The application circuit for Figure 19, the 100W Audio Amplifier, of the **LT<sup>®</sup>1166** data sheet has two corrections as indicated below. For complete specifications, typical performance characteristics and applications information, please see the **LT1166** data sheet.

### Changes Made in the Schematic:

### The Corrected Schematic:

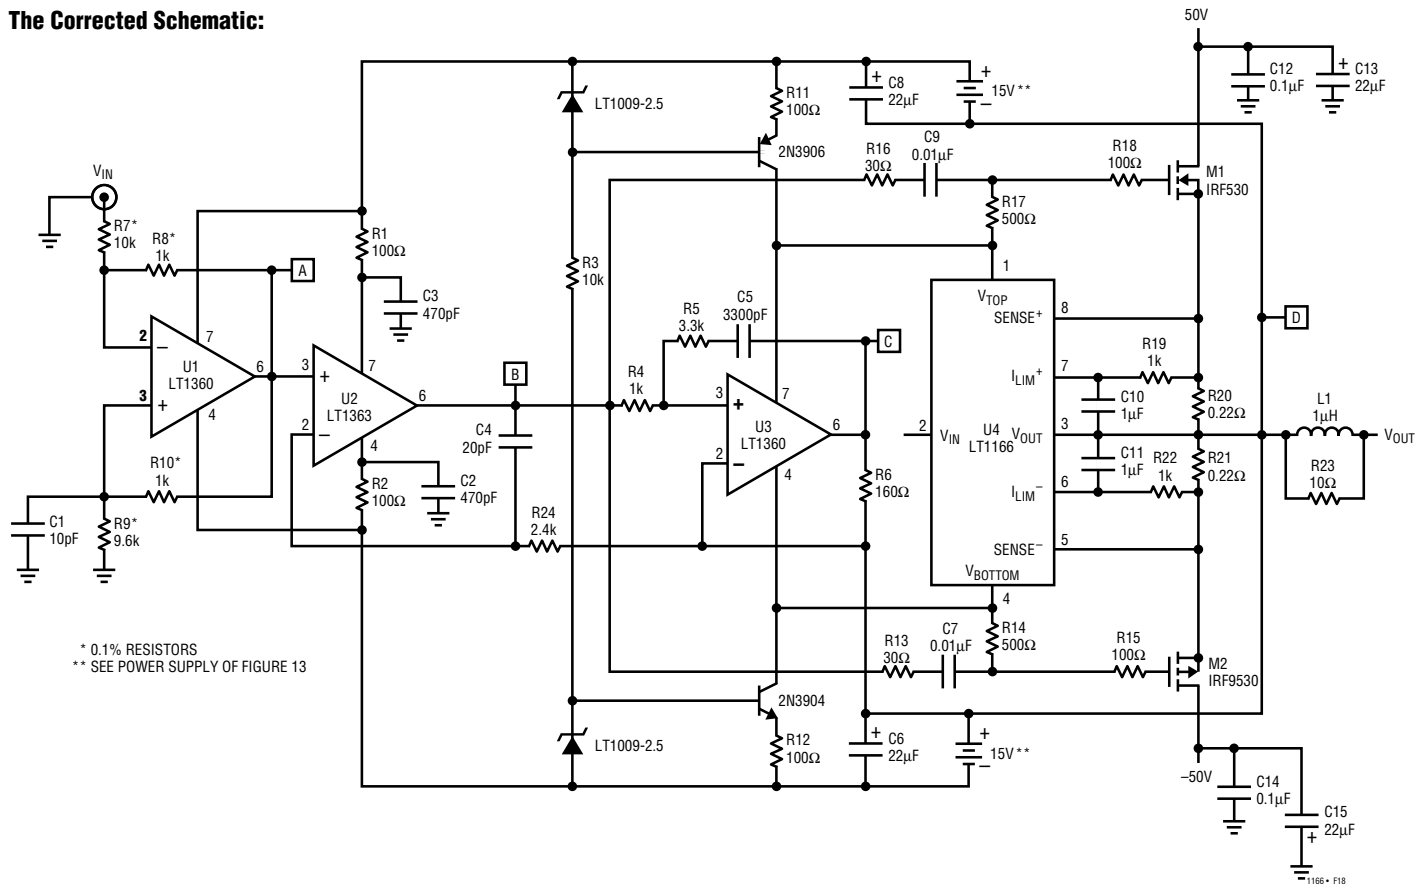
- 1) U1, LT1360: changed Pin 3 to Pin 2; changed Pin 2 to Pin 3
- 2) U3, LT1360: changed + sign to - sign; changed - sign to + sign
